ADDENDUM No. 1

Project Name:	Owner: City of Dexter Project Name: Dexter City Hall Renovations	Addendum No: One (1)
Project Number:	21-113	Issue Date: January 21, 2022
Project Location:	3515 Broad St. Dexter, Michigan 48130

2
A3-02 Building Section
1/4" = 1'-0"

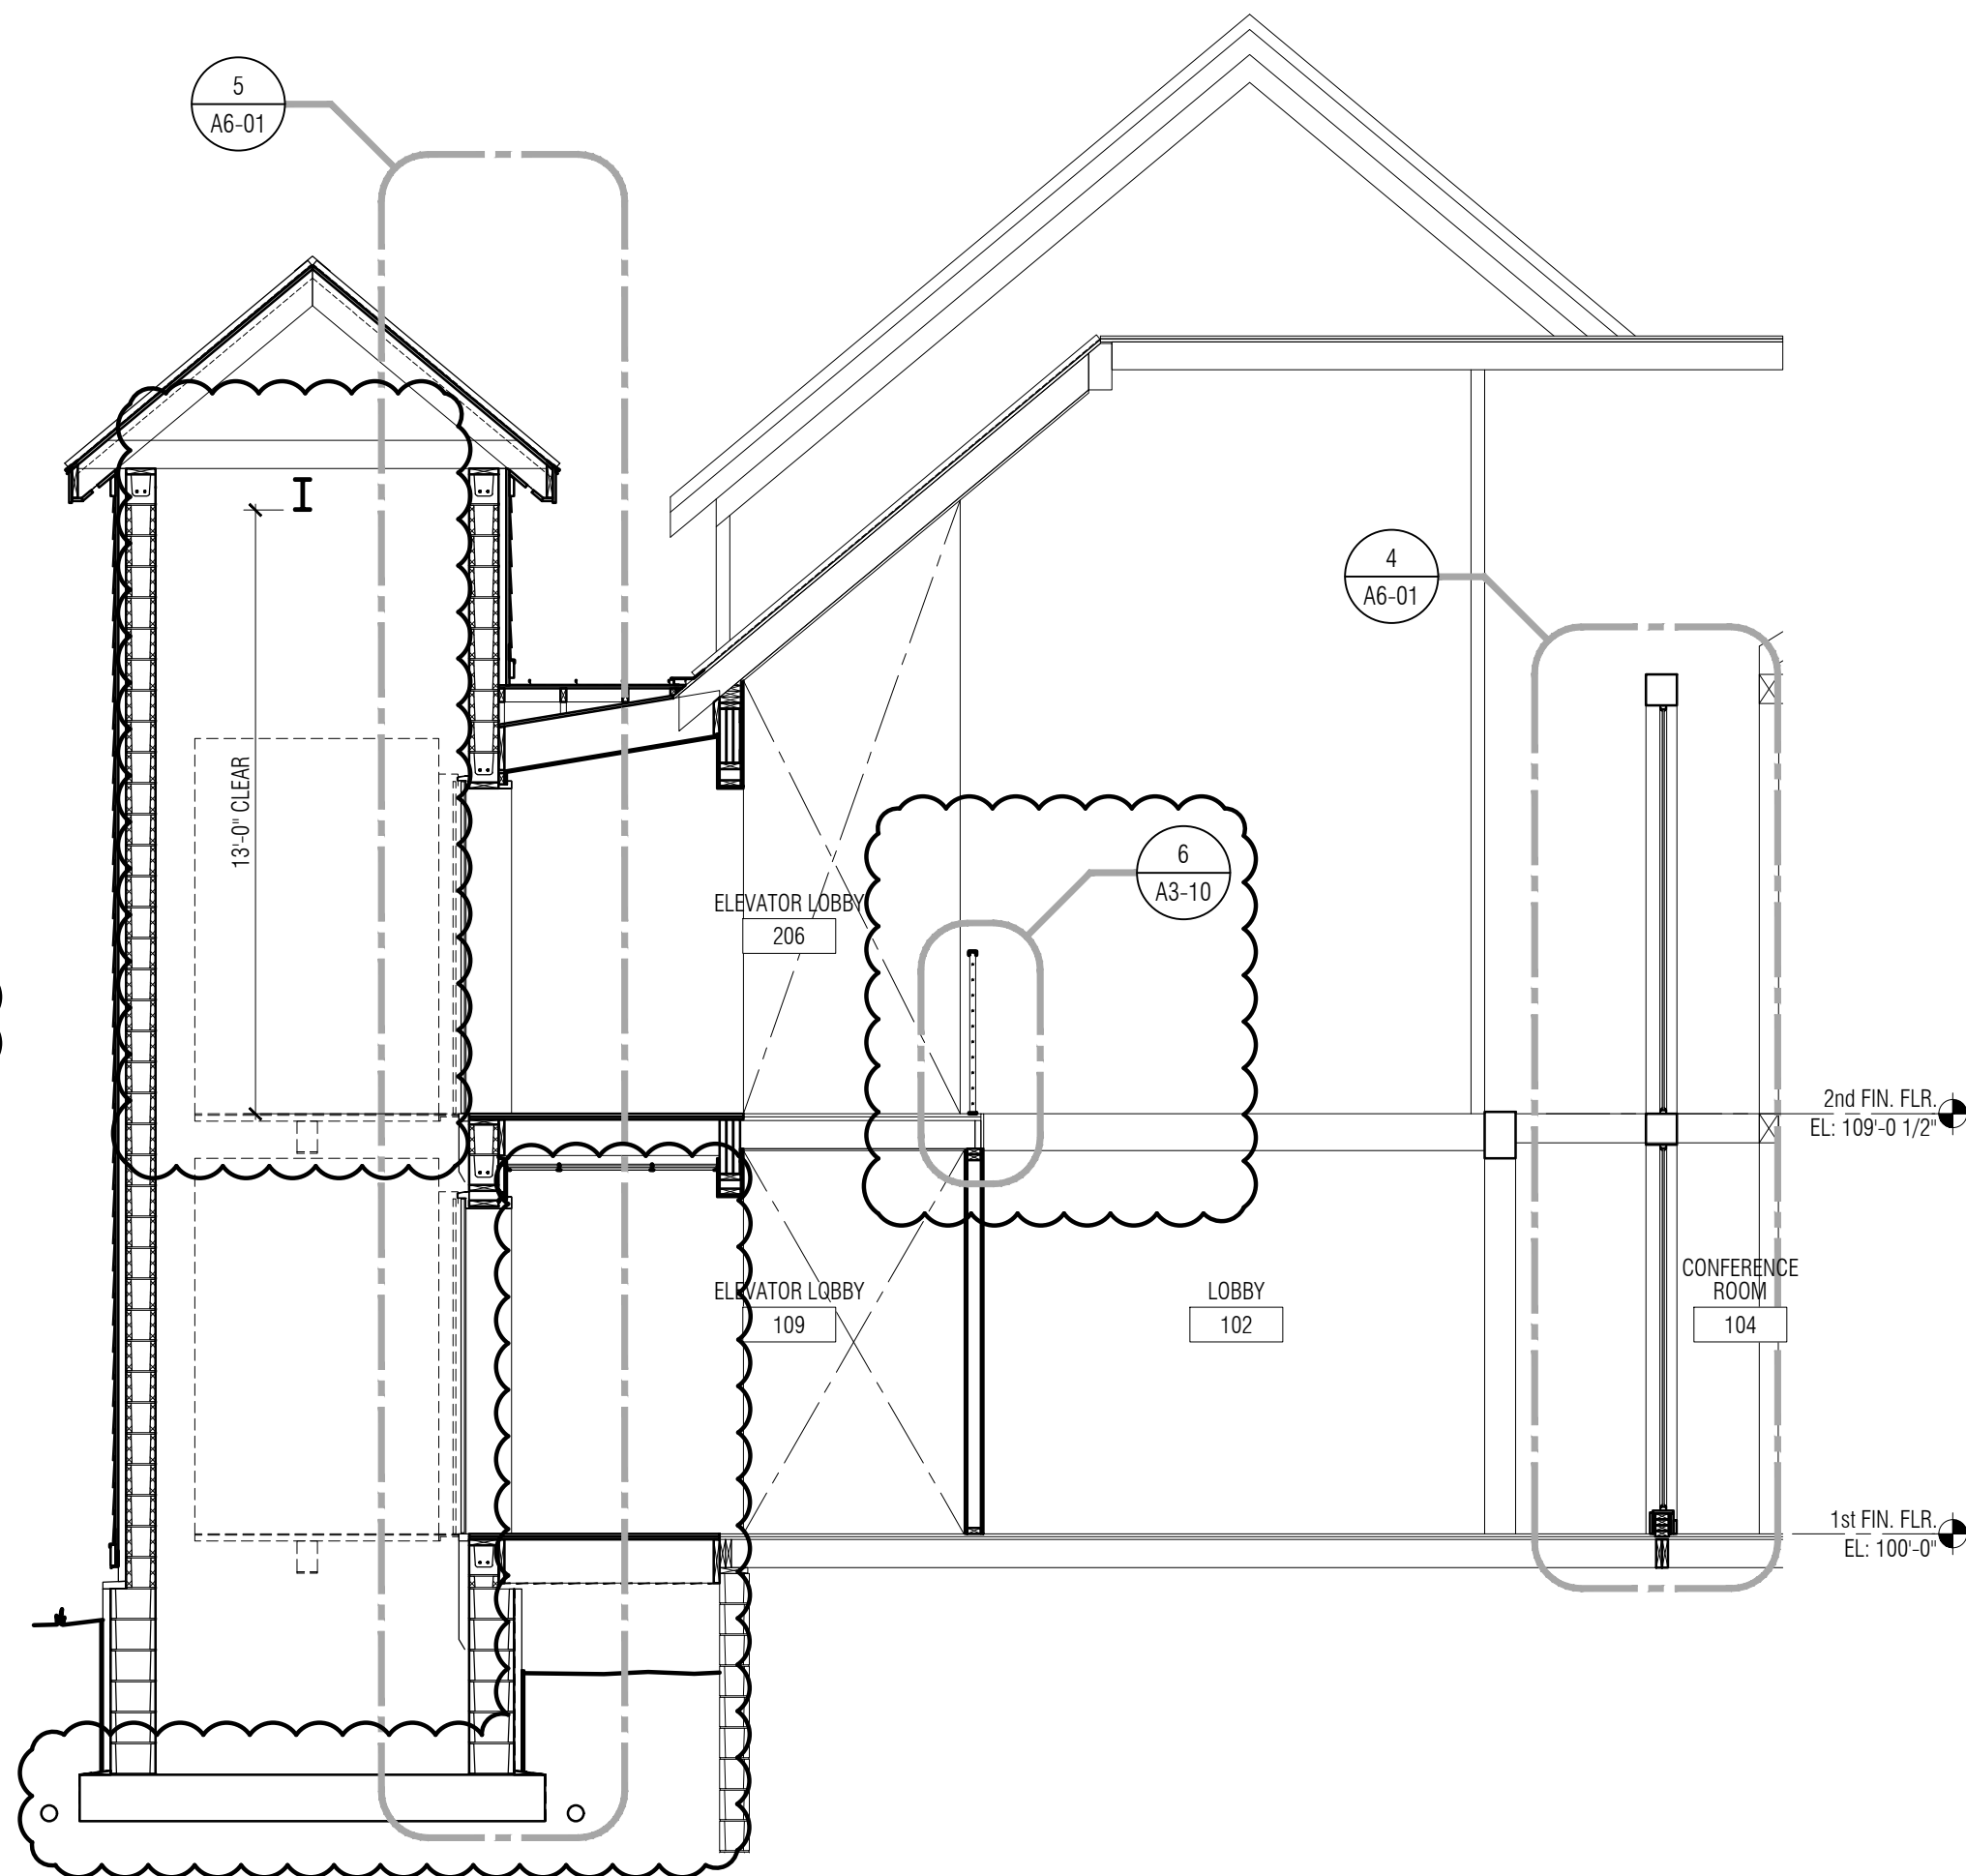
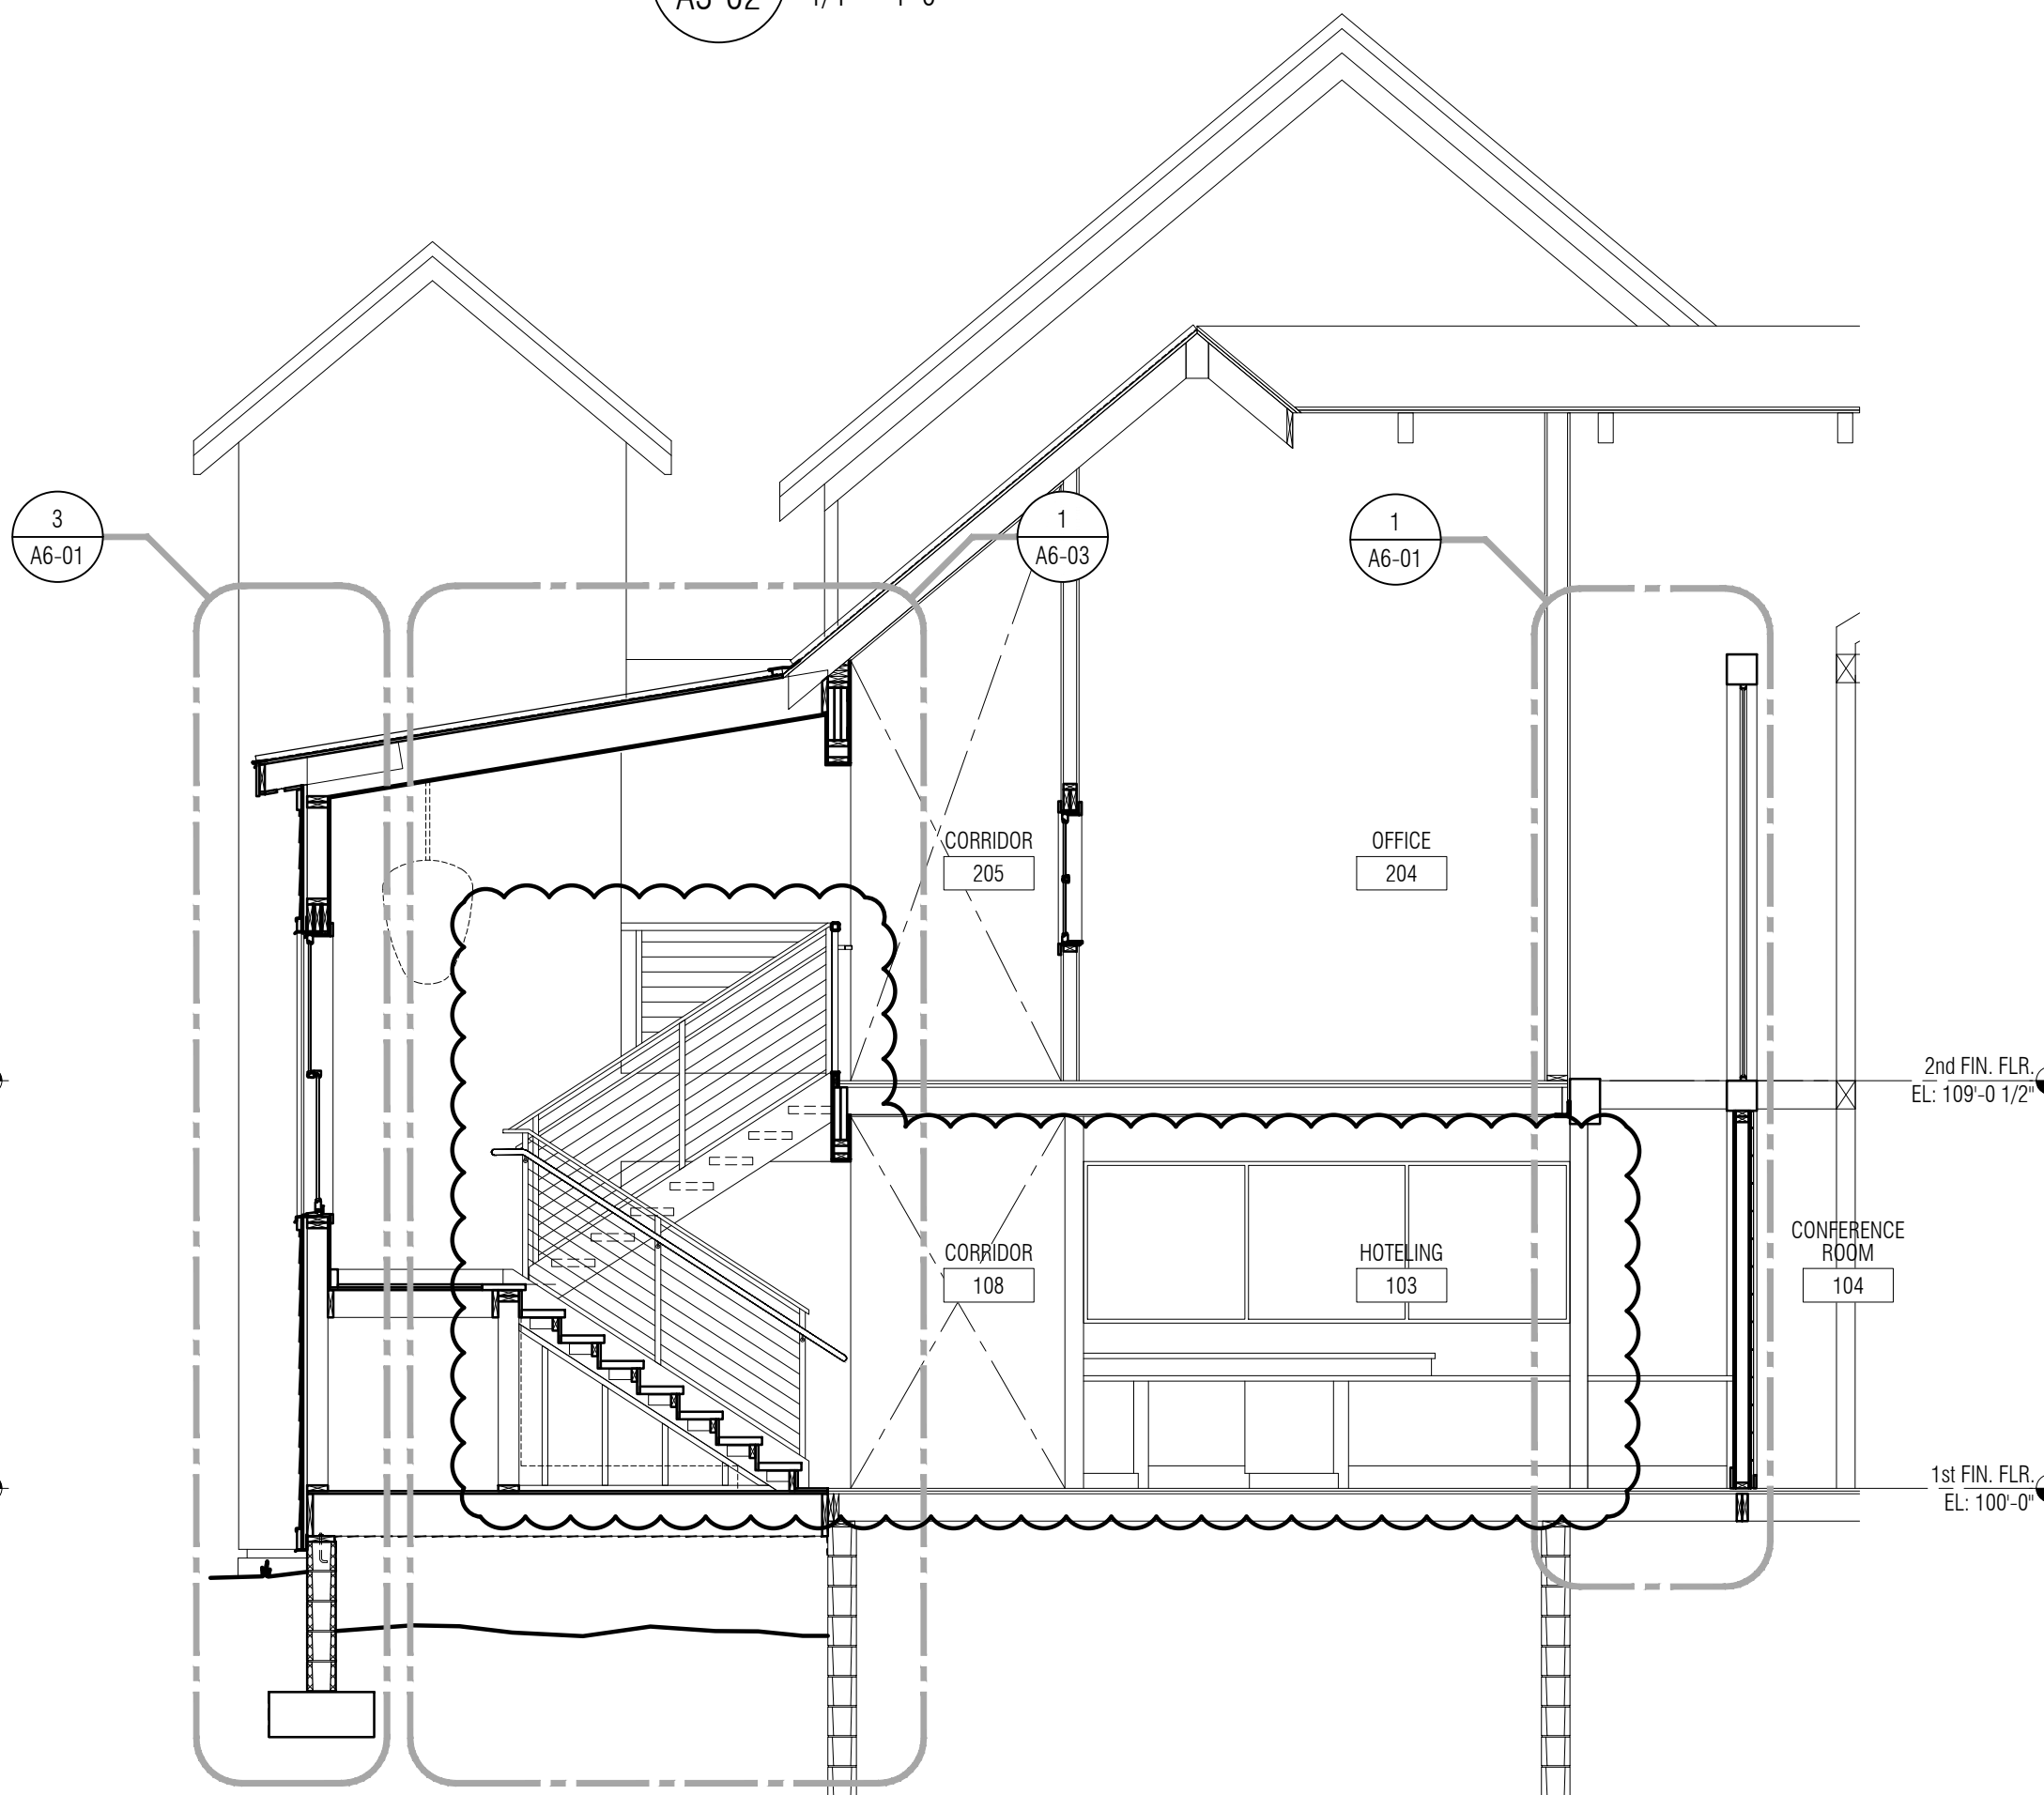
- ITEM A21** A5-10 Building Sections (Revised & Re-Issued)
- A. Filled out missing tag information on section 5.
 - B. Extended section 4 to show supported slab in front of vestibule.

- C. Updated note on section 3 to refer to deduct alternate #6, rather than add alternate # 3.
 - D. Removed door from section 2.
 - E. Now showing drain tile on both sides of elevator pit on section 2.

- F. Updated stair railing to show tension cable system, rather than vertical bars, on section 1.
 - G. Added detail of hoteling area per updated plan changes.
